ADDENDUM #1

Project: Ogden-Hinkley Airport
Remodel

Project Number: 2021-10

Date: 11.21.23

Sheet Number
S101

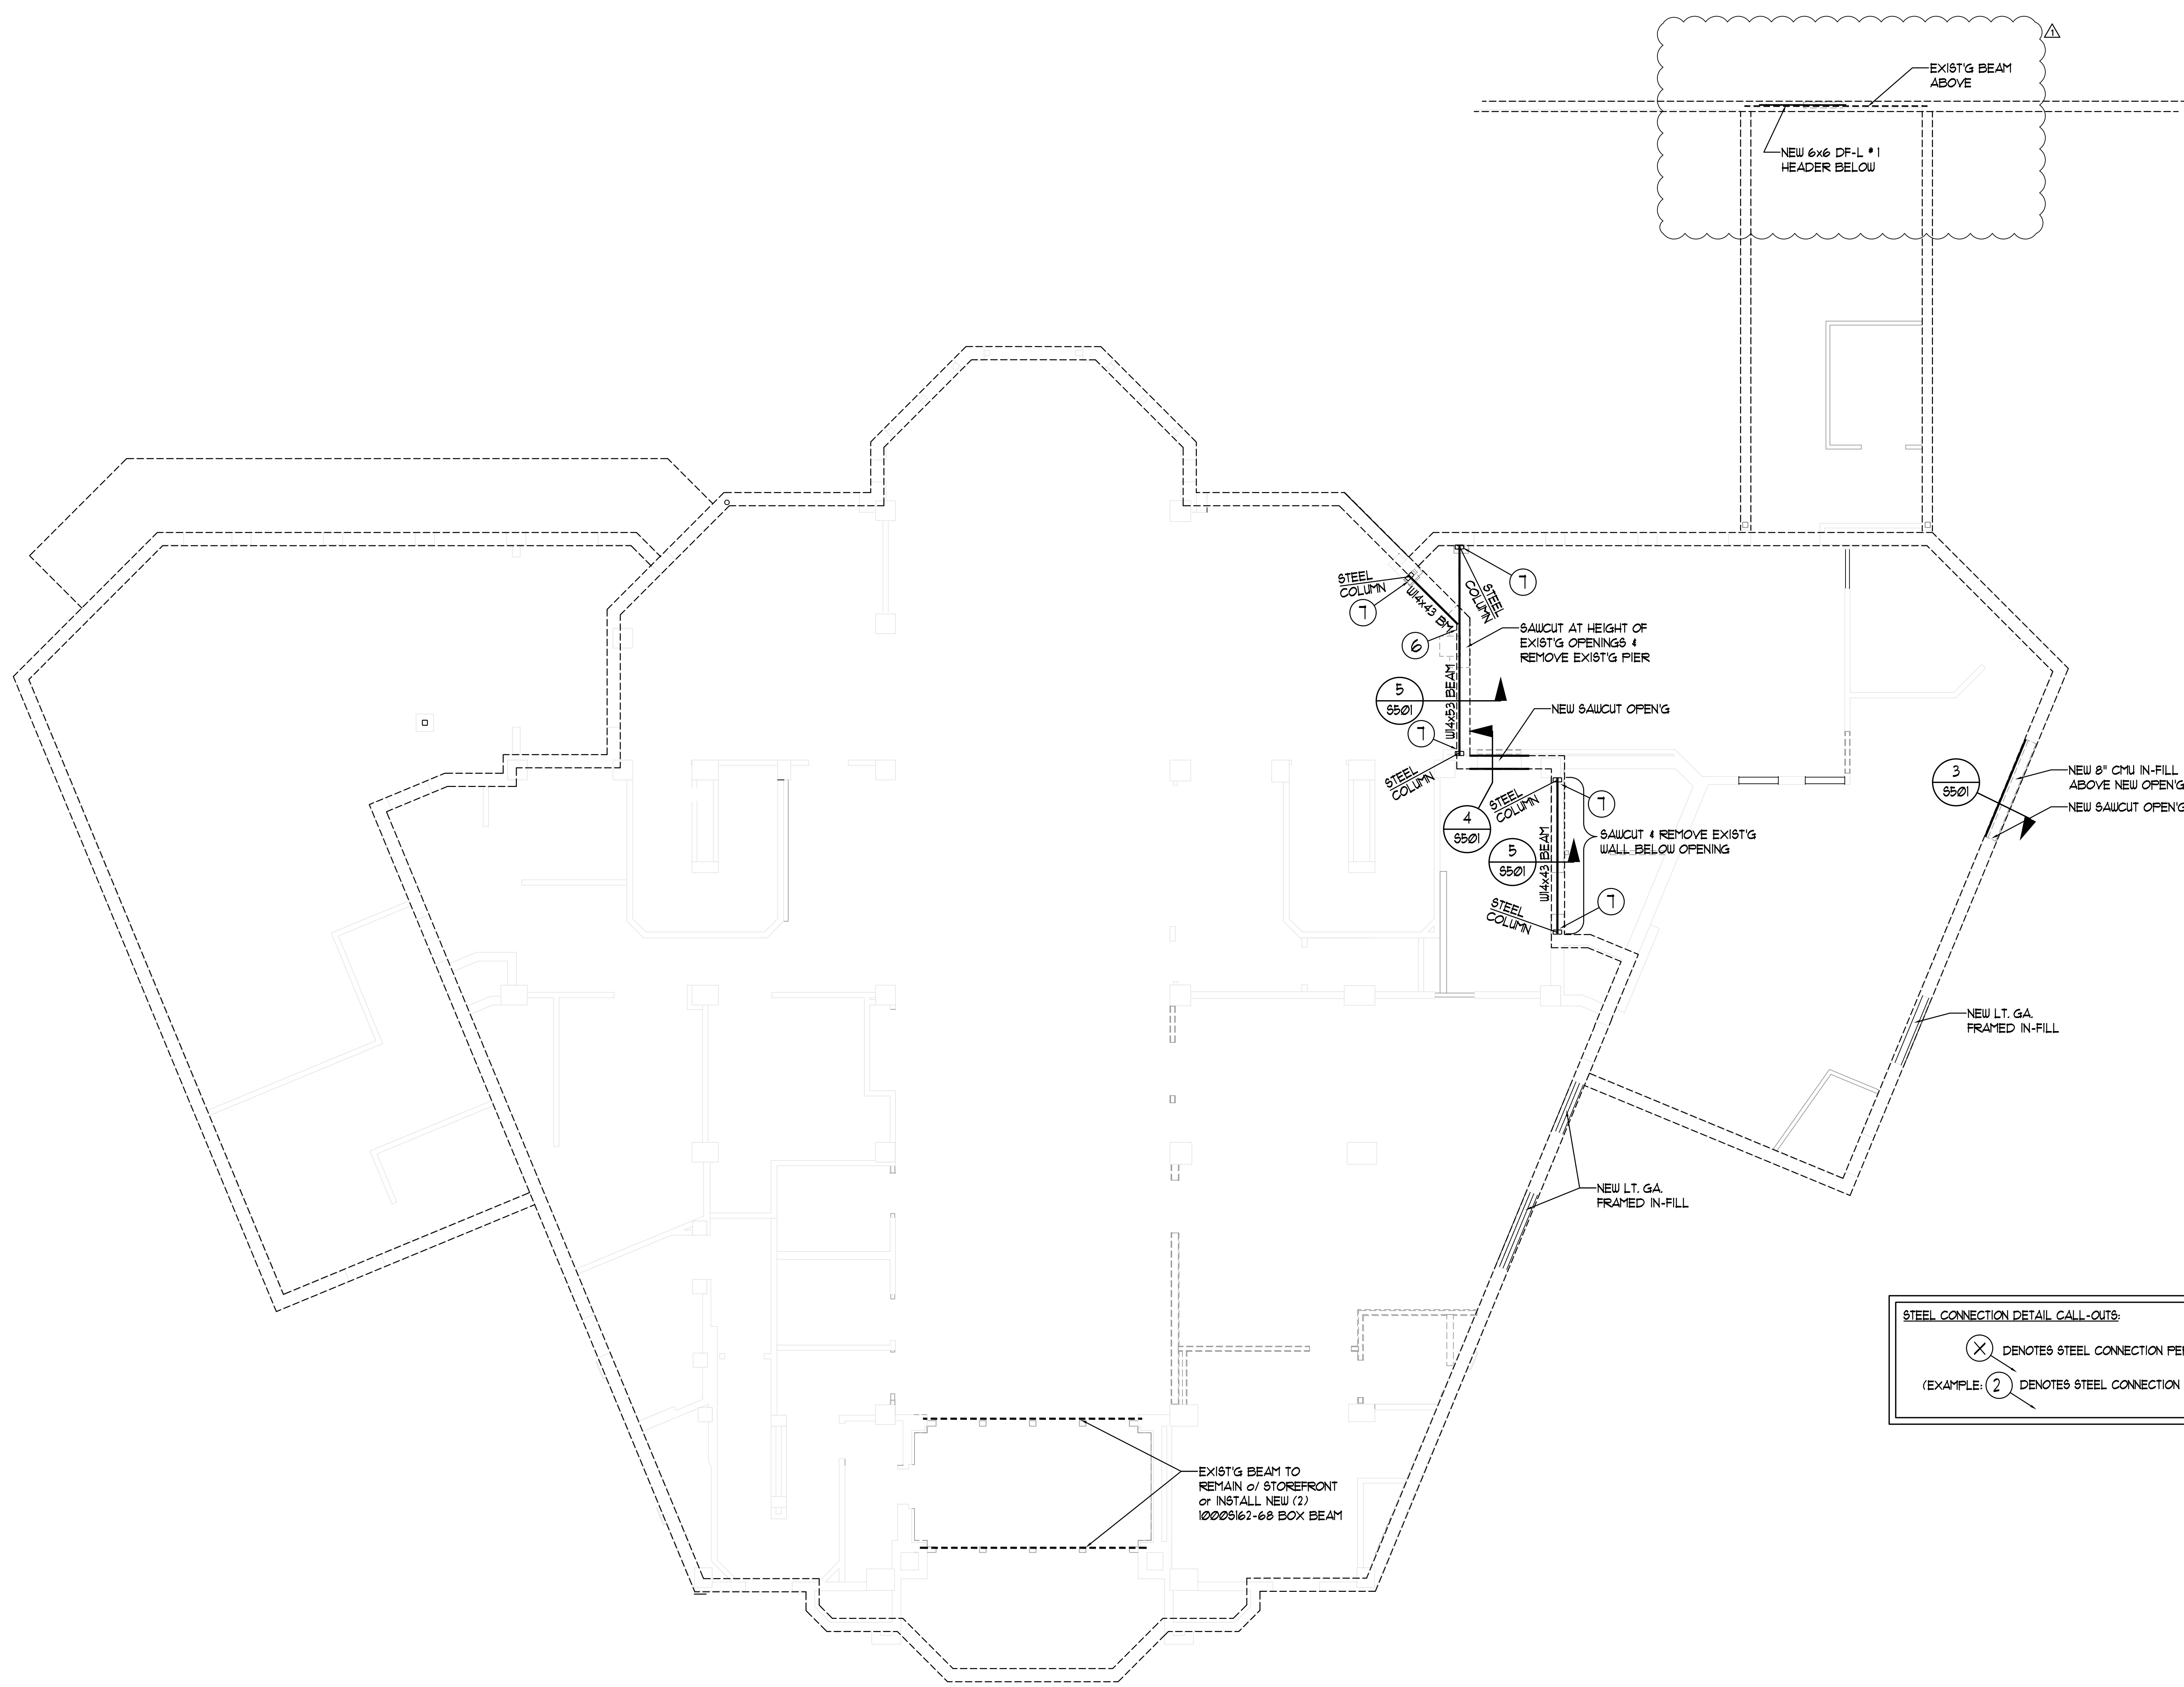
1. Drawing S101:
 - A. Note for the cutout for new door opening in wood framed wall added.
2. Drawing S102:
 - A. New wood header indicated for the cut-out opening in the existing wood framed wall.
